dsPIC30F1010/202X

dsPIC30F1010/202X Family Silicon Errata and Data Sheet Clarification

The dsPIC30F1010/202X family devices that you have received conform functionally to the current Device Data Sheet (DS70178C), except for the anomalies described in this document.

FIGURE 1:

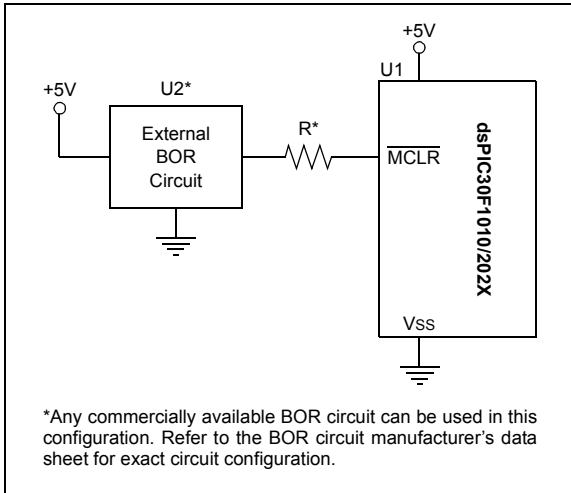
31. Module: MCLR

A brown-out event occurs when VDD drops below the minimum operating voltage for the device, but not all the way down to VSS. When the dsPIC DSC SMPS device is running with the PLL enabled, and a brown-out event occurs, the device may stop running and the MCLR pin will not reset the device. If this occurs, the device can only be reset by cycling power to the VDD pins.

It is recommended that an external Brown-out Reset (BOR) circuit be used to hold the device in Reset, during a brown-out event, to overcome this problem. The external BOR circuit will use the MCLR pin to hold the device in Reset. The following work around, in combination with the external BOR circuit, will ensure that the device is cleanly reset after a brown-out event occurs.

The dsPIC DSC SMPS device must be powered up with the PLL disabled, the Fail-Safe Clock Monitor (FSCM) enabled and clock switching enabled. The PLL should be enabled in software via a clock switch after the device is reset (refer to **Section 29. "Oscillator"** (DS70268) in the "*dsPIC30F Family Reference Manual*" for details on clock switching). This ensures that the MCLR pin is functional and that the device can be reset by an external BOR circuit (see [Figure 1](#)).
